**PCN#20160630000**  
**Qualification of AMKOR P3 as Additional Assembly and Test Site**  
**for Select LSON-CLIP Package Devices**  
**Change Notification / Sample Request**

<b>PCN Number:</b>	20160630000			<b>PCN Date:</b>	07/05/2016												
<b>Title:</b>	Qualification of AMKOR P3 as Additional Assembly and Test Site for Select LSON-CLIP Package Devices																
<b>Customer Contact:</b>	<a href="#">PCN Manager</a>	<b>Dept:</b>	Quality Services														
<b>Proposed 1<sup>st</sup> Ship Date:</b>	10/05/2016		<b>Estimated Sample Availability:</b>	Date provided at sample request													
<b>Change Type:</b>																	
<input checked="" type="checkbox"/>	Assembly Site	<input type="checkbox"/>	Design	<input type="checkbox"/>	Wafer Bump Site												
<input checked="" type="checkbox"/>	Assembly Process	<input type="checkbox"/>	Data Sheet	<input type="checkbox"/>	Wafer Bump Material												
<input checked="" type="checkbox"/>	Assembly Materials	<input type="checkbox"/>	Part number change	<input type="checkbox"/>	Wafer Bump Process

Sample product shipping label (not actual product label)

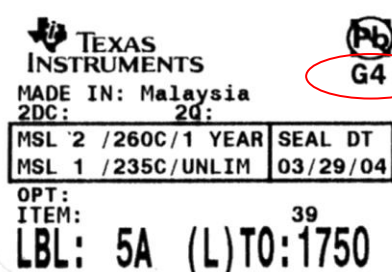
## Changes to product identification resulting from this PCN:

TI-CLARK	Assembly Site Origin (22L)	ASO: QAB	ECAT: G4
AMKOR P3	Assembly Site Origin (22L)	ASO: AP3	ECAT: G3

ECAT: G4 = NiPdAu  
ECAT: G3 = Matte Sn

ASSEMBLY SITE CODES: TI-CLARK = I , AP3 = 3
